OLD PATCH HOUSE, RHODODENDRON STATE PARK EVALUATION OF EXISTING CONDITIONS AND REVIEW OF PROPOSED REHABILITATION

JAMES L. GARVIN

AUGUST 8, 1984

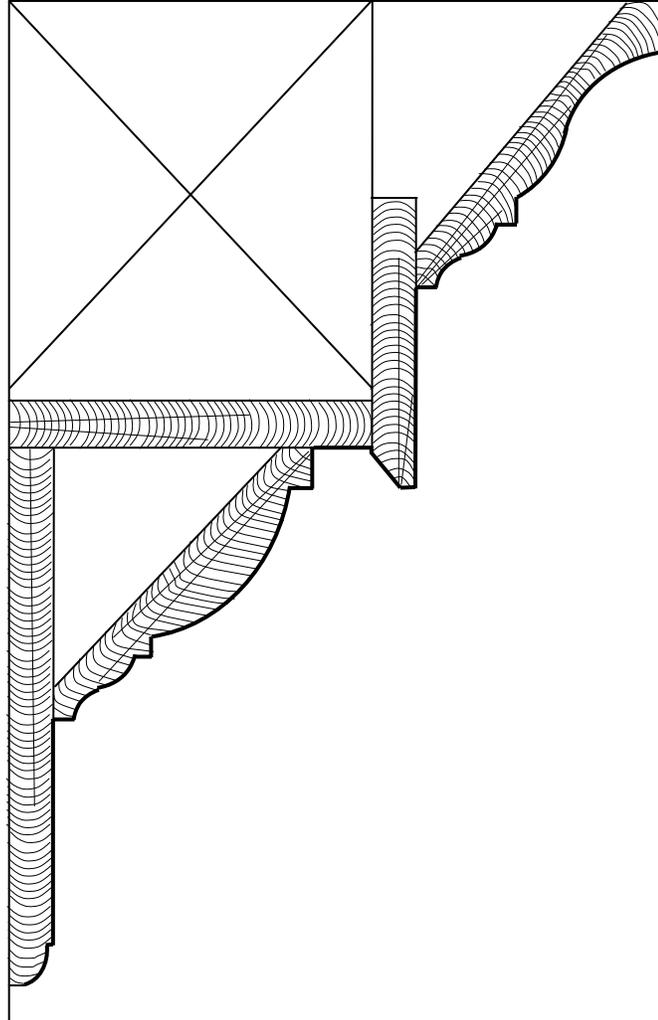
Some attempt might be made to reproduce original colors on the painted woodwork.
